**PLANNING COMMISSION AGENDA
CITY OF PRAIRIE VILLAGE
TUESDAY, SEPTEMBER 13, 2022
7700 MISSION ROAD
COUNCIL CHAMBERS
7:00 P.M.**

TO: Prairie Village Planning Commission
FROM: Chris Brewster, Gould Evans, Planning Consultant
DATE: September 13, 2022 Planning Commission Meeting

Request: Site plan review for solar panels, with an exception

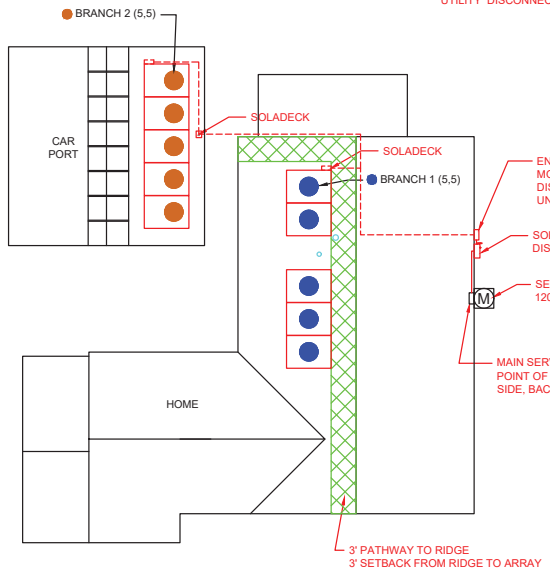
ADJUST HEIGHT TO 6"

In July we had a small (4kw) photovoltaic solar system installed at our home. On final inspection the City Inspector passed all aspects of the installation but noted that the panels looked like they were installed with more than 5" from the face of the panel to the roof shingles. We checked and the face of the panel was in fact 7" above the roof. The panel attachment system has some adjustment, and the face has since been lowered to 5 ¾" above the roof.

Staff recommends approval of this site plan with the exception to allow the panels to project approximately 5.8 to 6.0 inches above the roof surface due to:

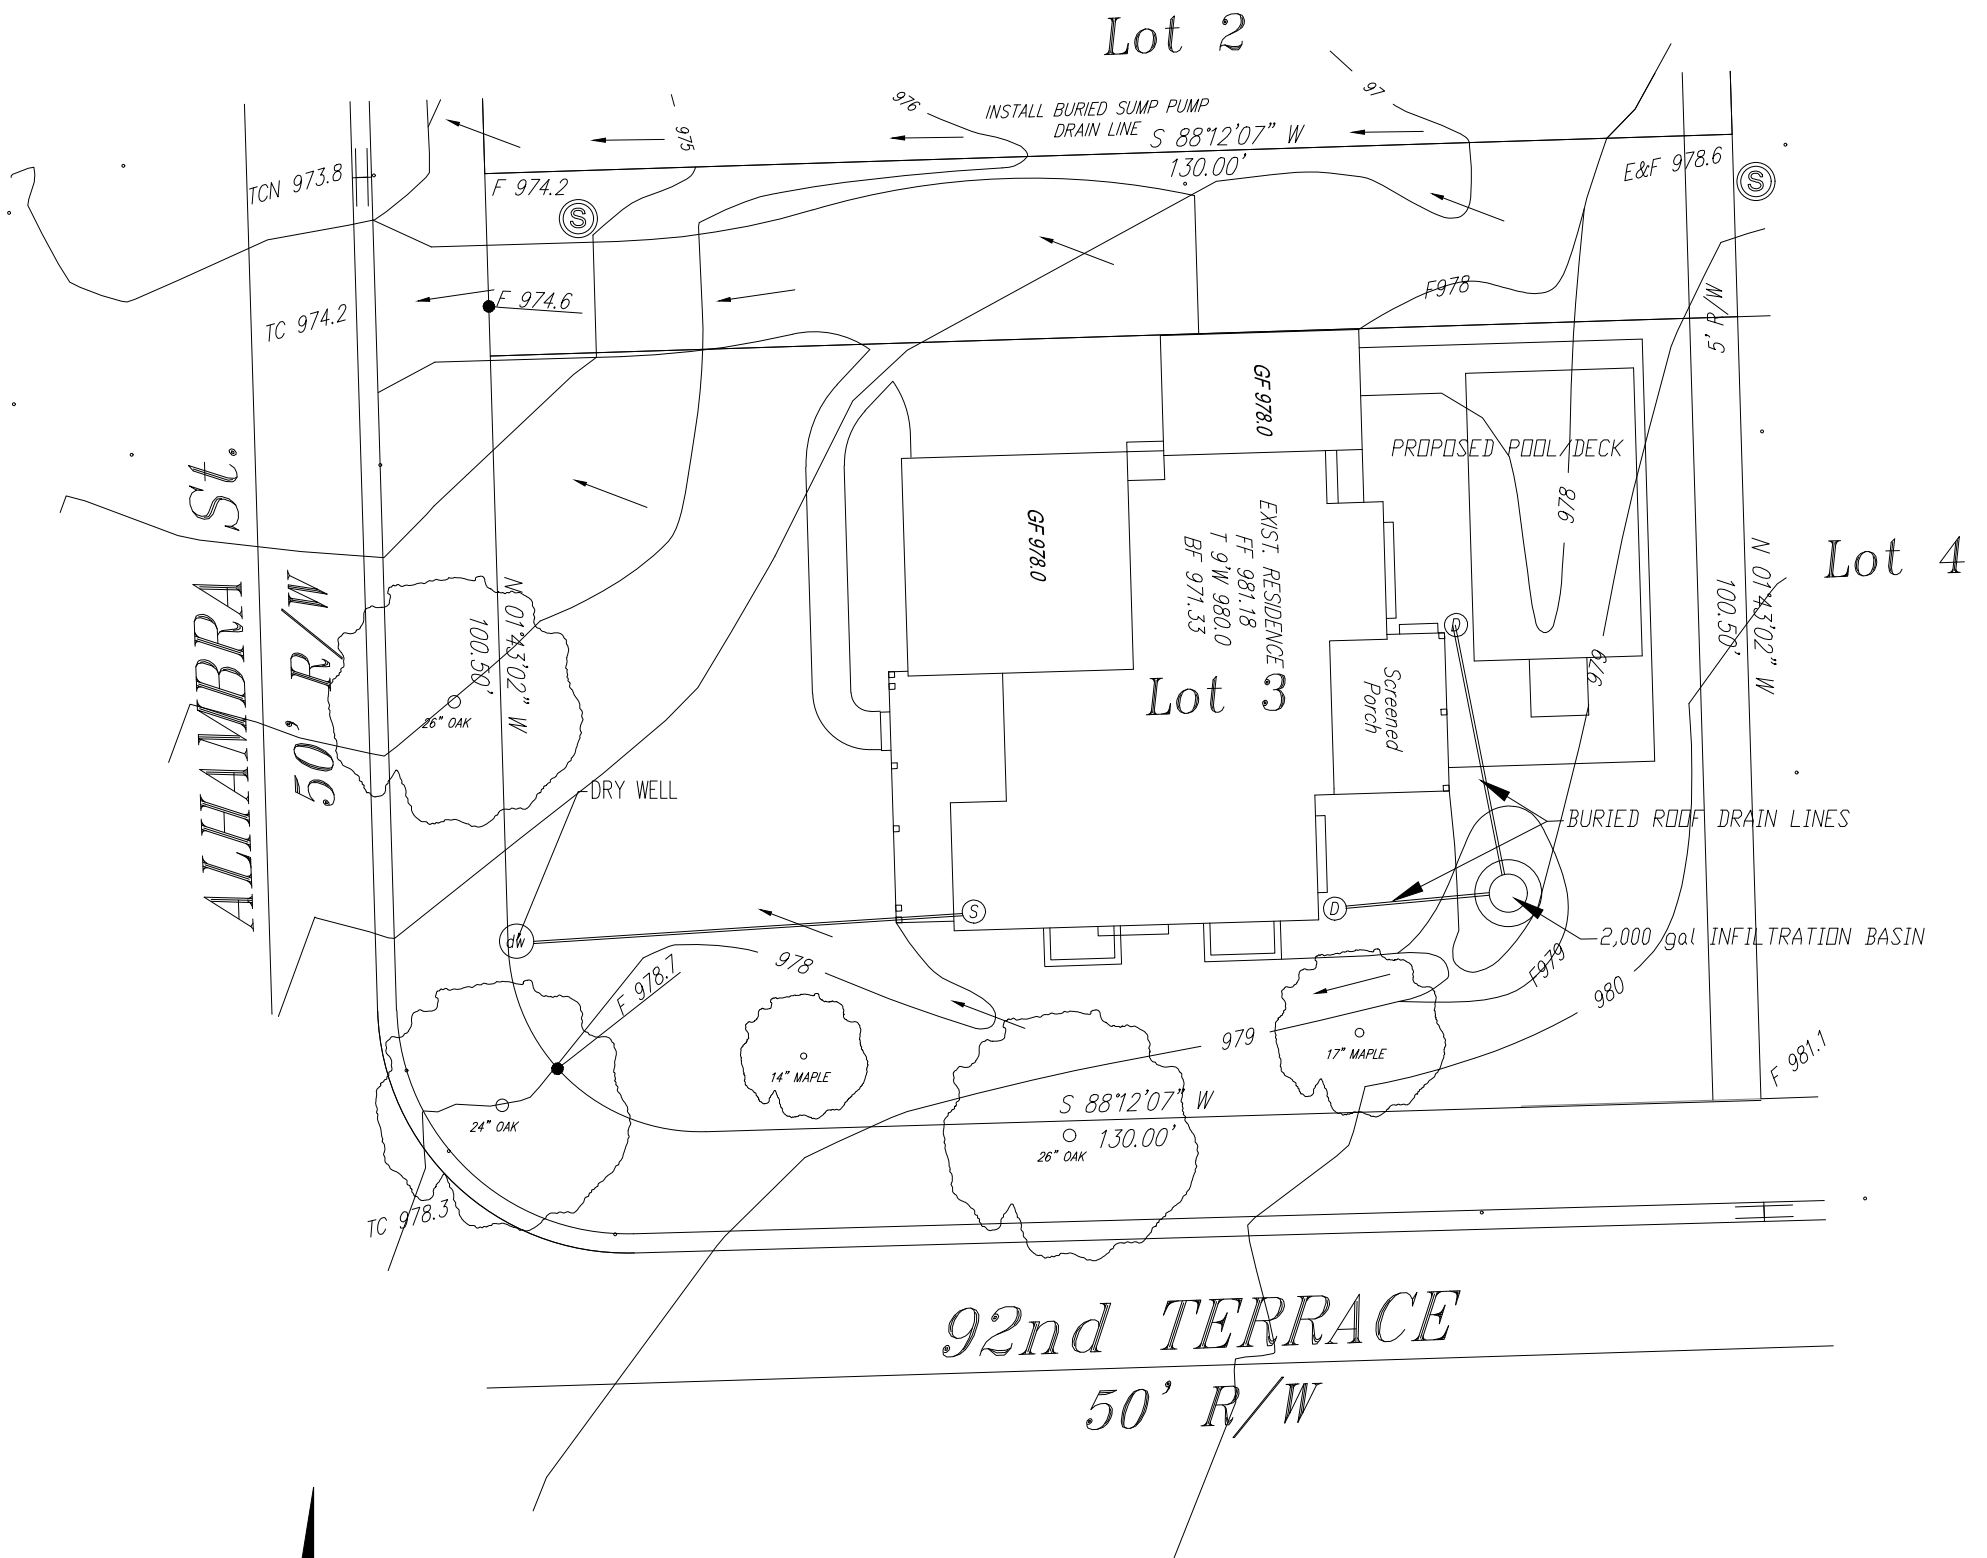
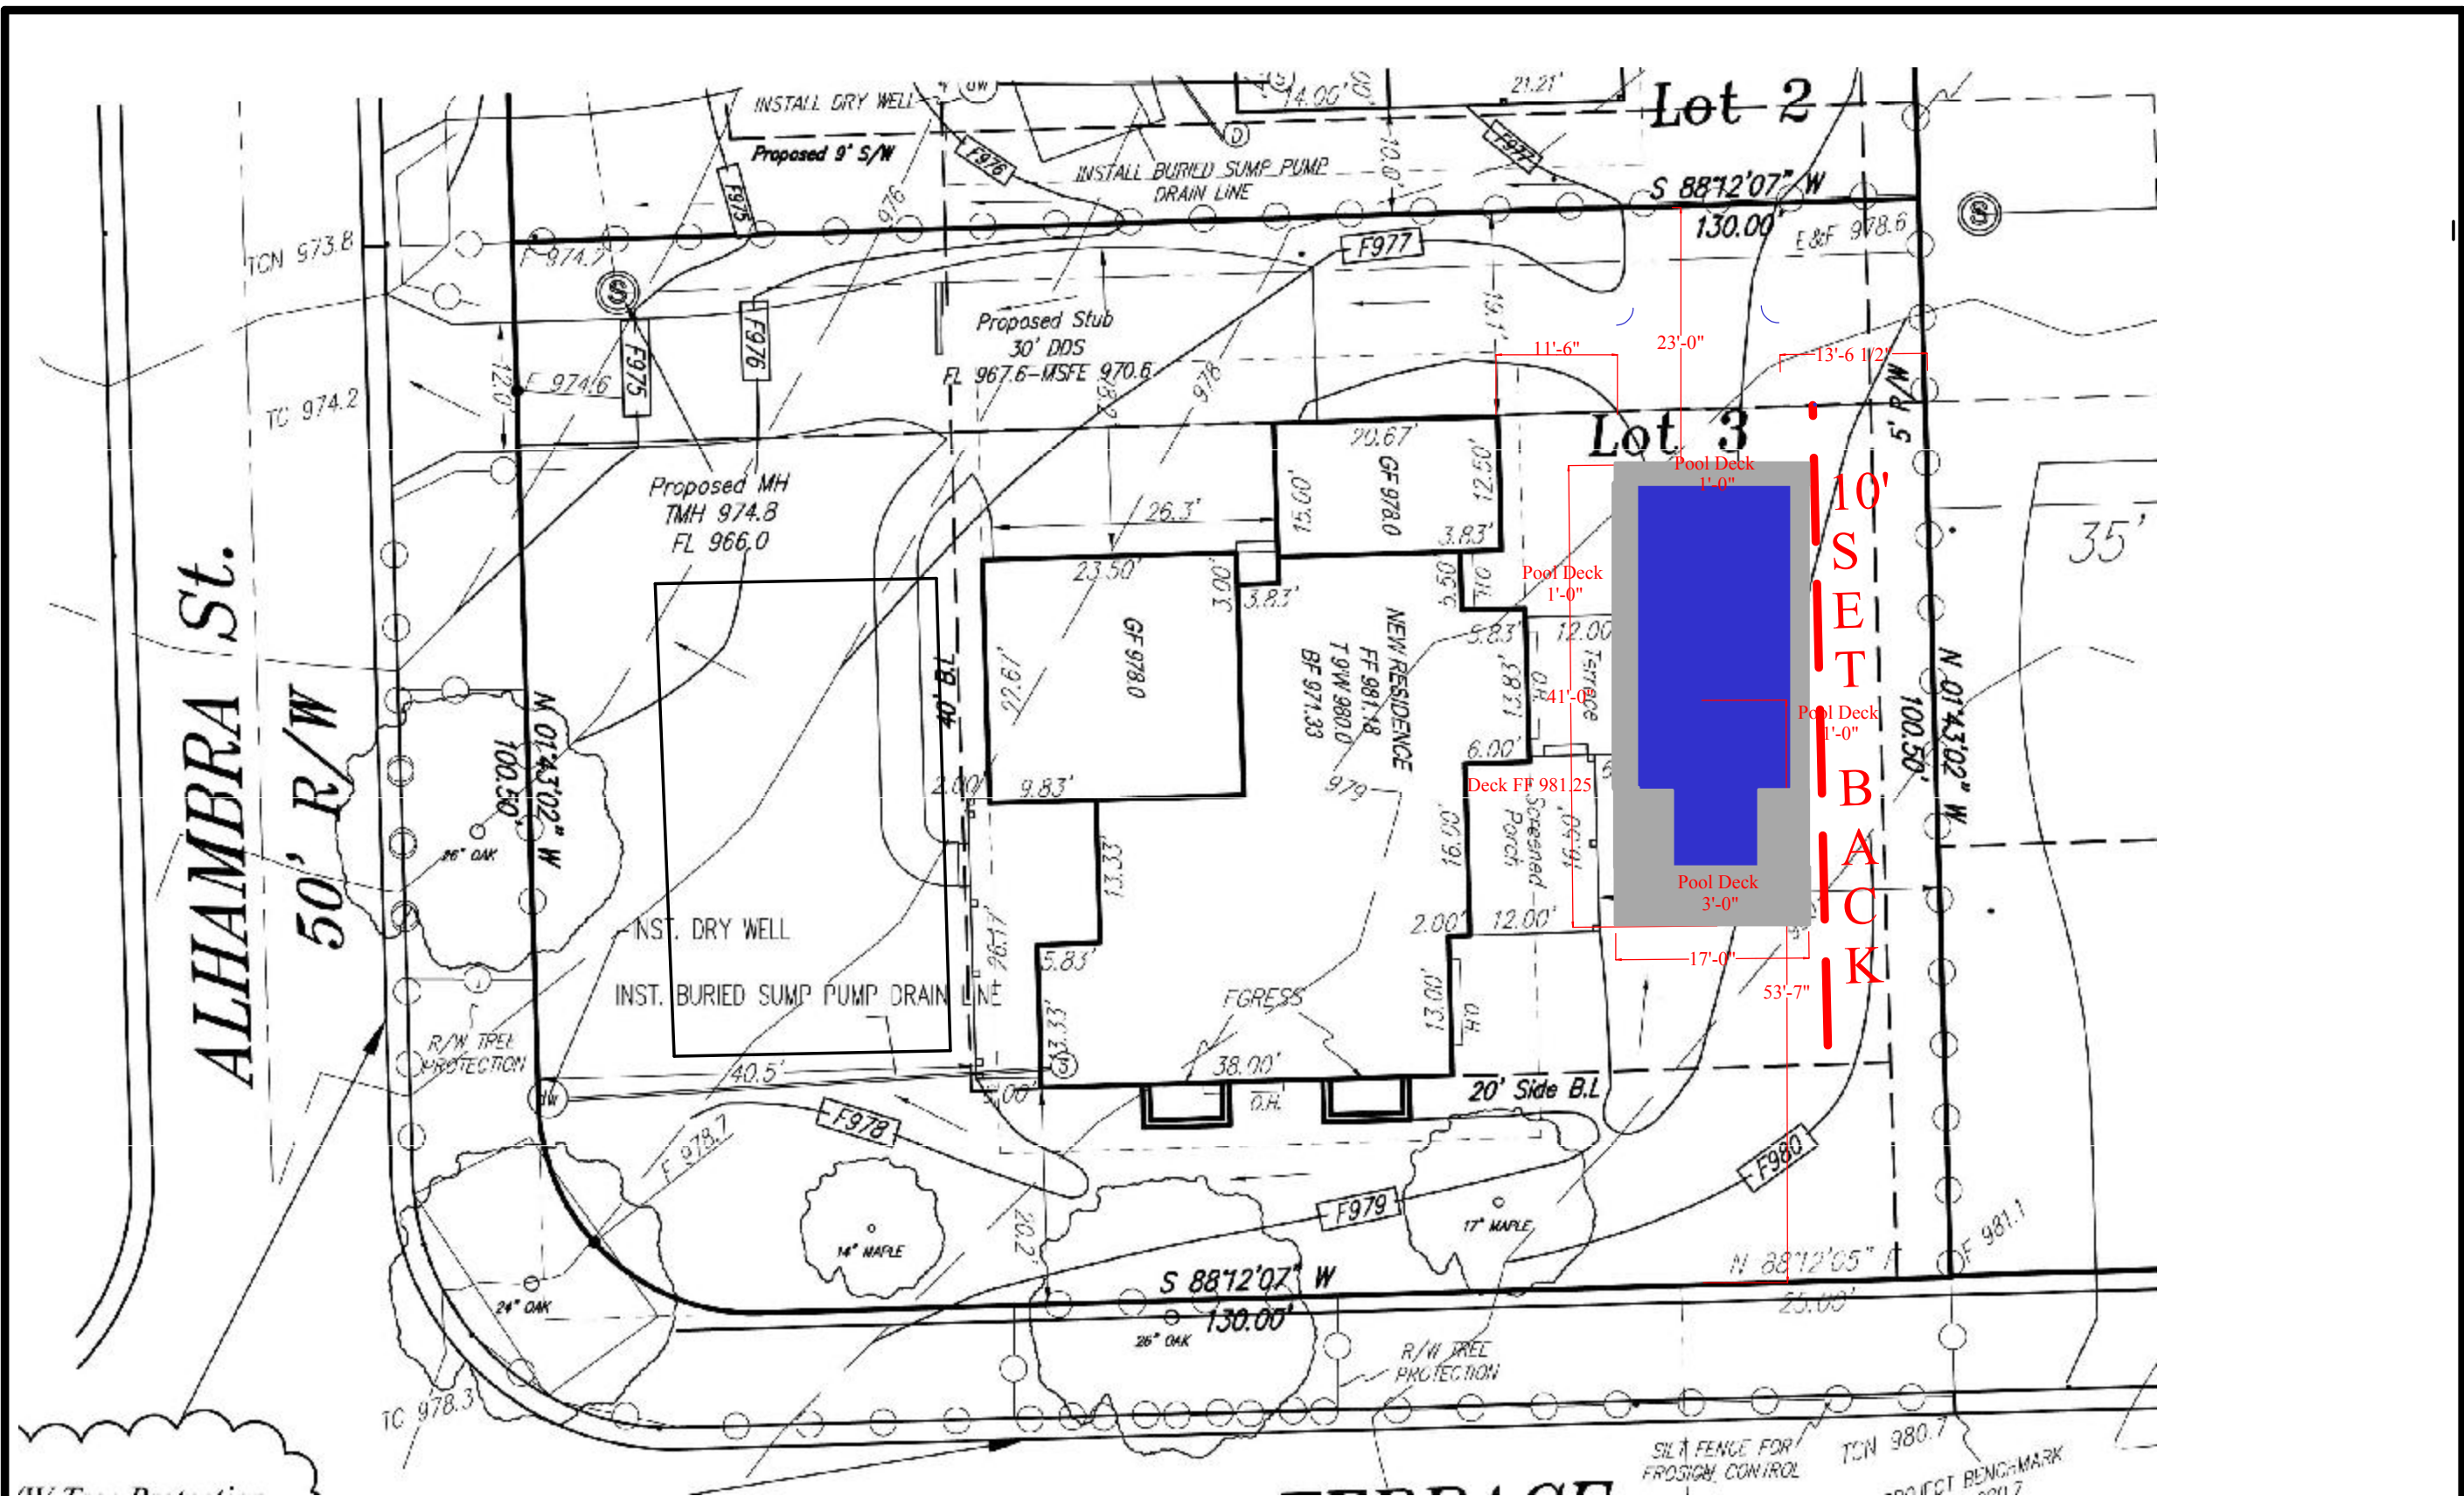
Based on a plan review of the proposed pool and deck area, the application does not meet the 40% lot coverage, and is 40.9% (Lot size = 12,987 s.f.; Existing impervious coverage 4,495 s.f.; proposed pool/deck = 324 s.f.)

1. The updated site plan with the added surrounding pool patio now exceeds the 40% allowed maximum impervious surface for the lot. Original Building documents/site plan detail:
 - Lot size 12,987 SF
 - 40% of 12,987 = 5194.8 Maximum allowed for this lot per PVZC table 19.06.A
 - The proposed new impervious surface calculated at; existing impervious 4495 SF + new pool and patio = 5319 SF indicates this project is **over by 124.2 Square feet**.
2. Applicant needs to reduce the amount of impervious surface and resubmit; site plan shall indicate the final outside dimensions of the pool and patio area. Provide a final impervious surface calculation of the lot on the site plan.
3. Applicant shall update the drainage permit that was previously approved by the public Works Department after corrections have been made. Contact 913-385-4647 for submittal procedures.

Staff recommends approval of this site plan with the lot coverage exception based on the following considerations:

- The limited nature of the exception (approximately 0.9% from the standard) and the negligible impact it will have on overall stormwater policies for the City.
- The drainage plan for the specific improvements demonstrating no adverse impact on the abutting property or the overall stormwater system.

ILLUMINATED MONUMENT SIGN

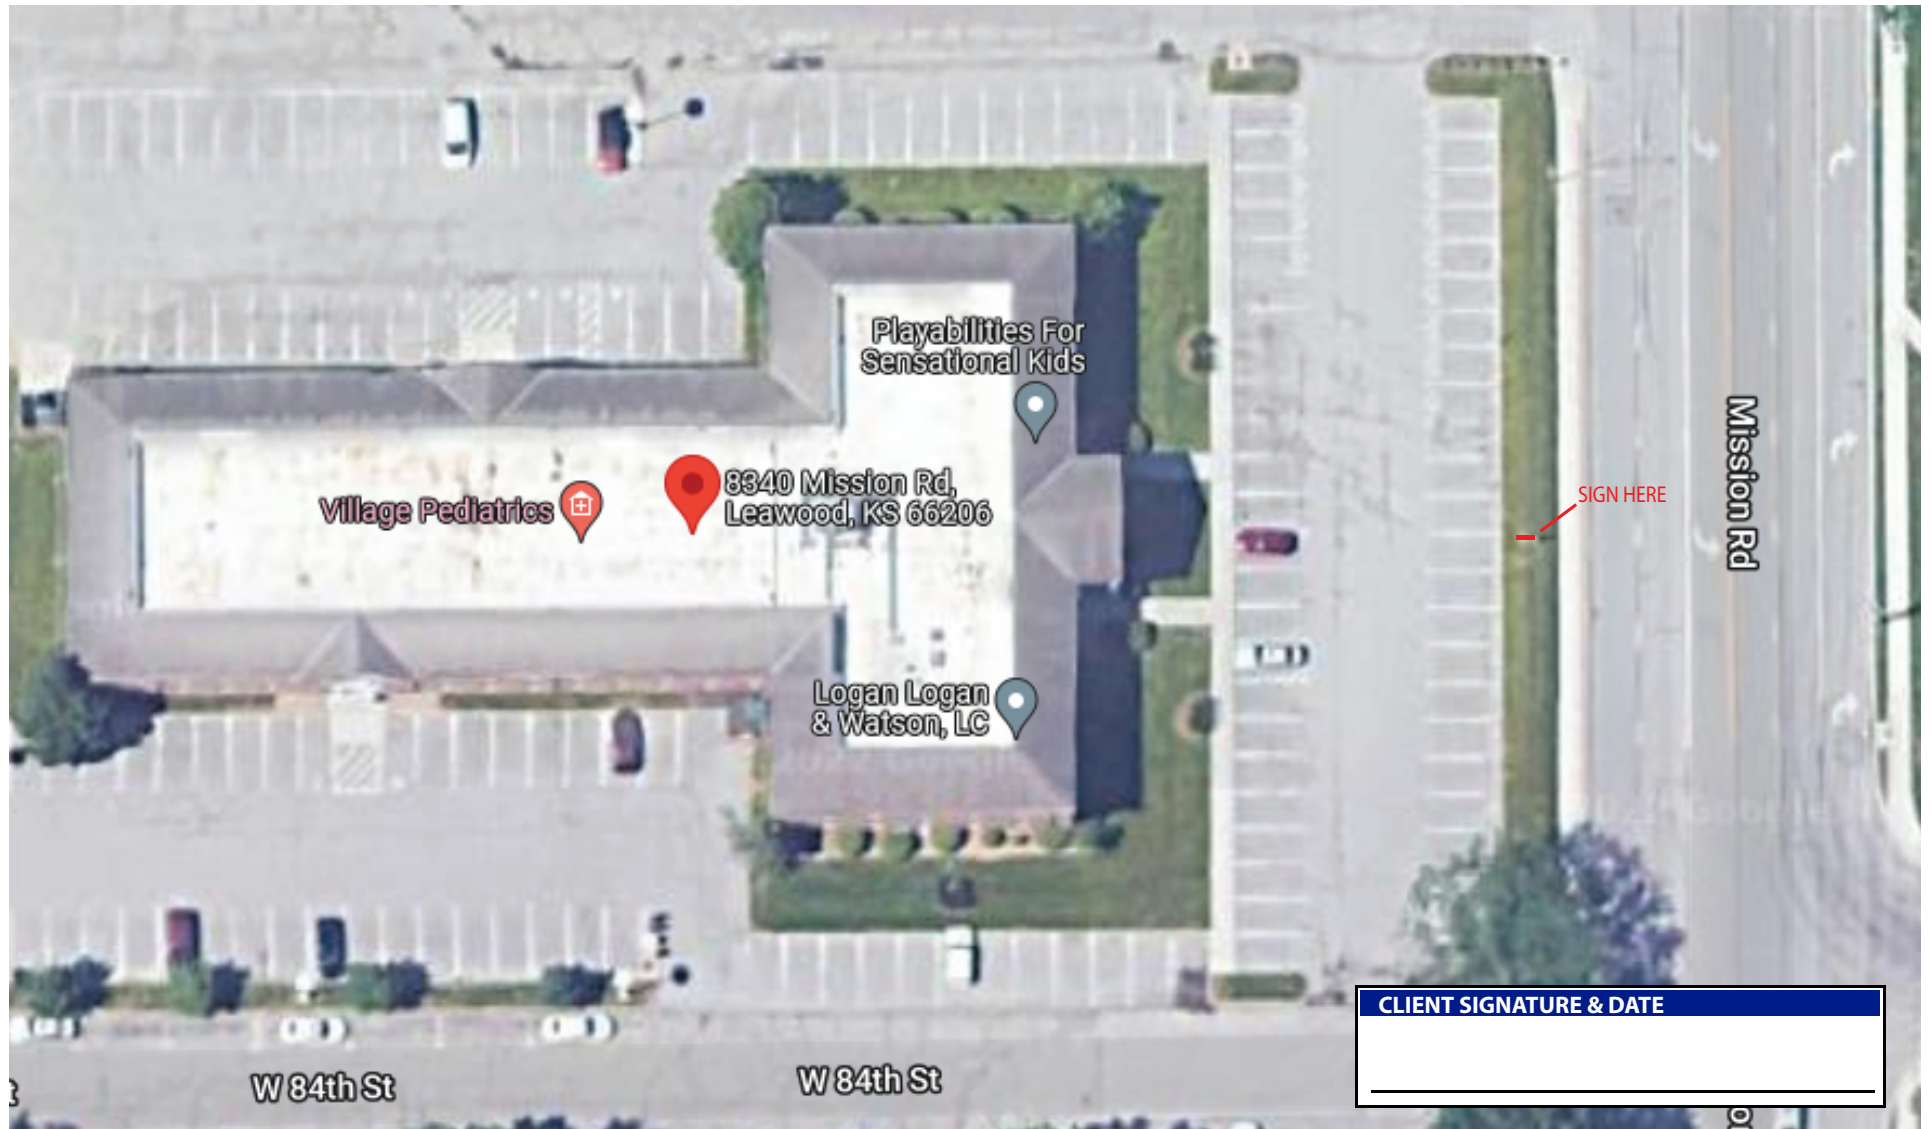
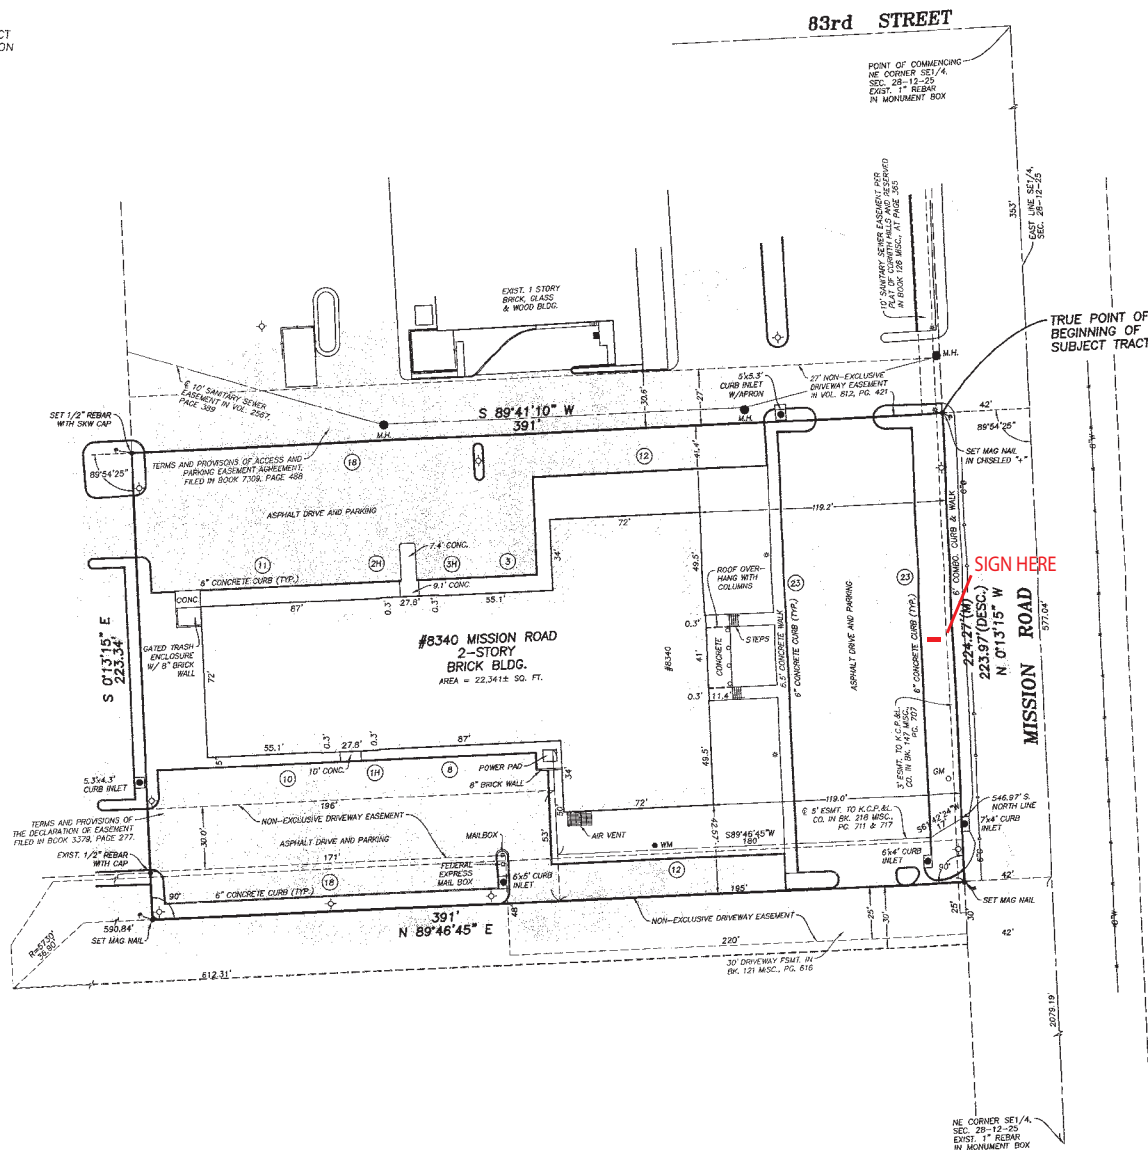
The sign is properly situated in a landscape area at least 3 feet on all sides. However, detailed landscape plans are not included in the submittal. Some ground-level ornamental plantings may be necessary to integrate the sign better into the landscape buffer along the parking frontage.

1. The applicant confirms to Planning Commission the color combinations of the sign panel and tenant backing, and particularly the conformance guidelines in 19.48.080 (a) and (b); and
 2. The applicant submits detailed landscape plan for the base (# of plants, species, etc.) to be approved by the City's landscape architect consultant prior to sign permits.
-
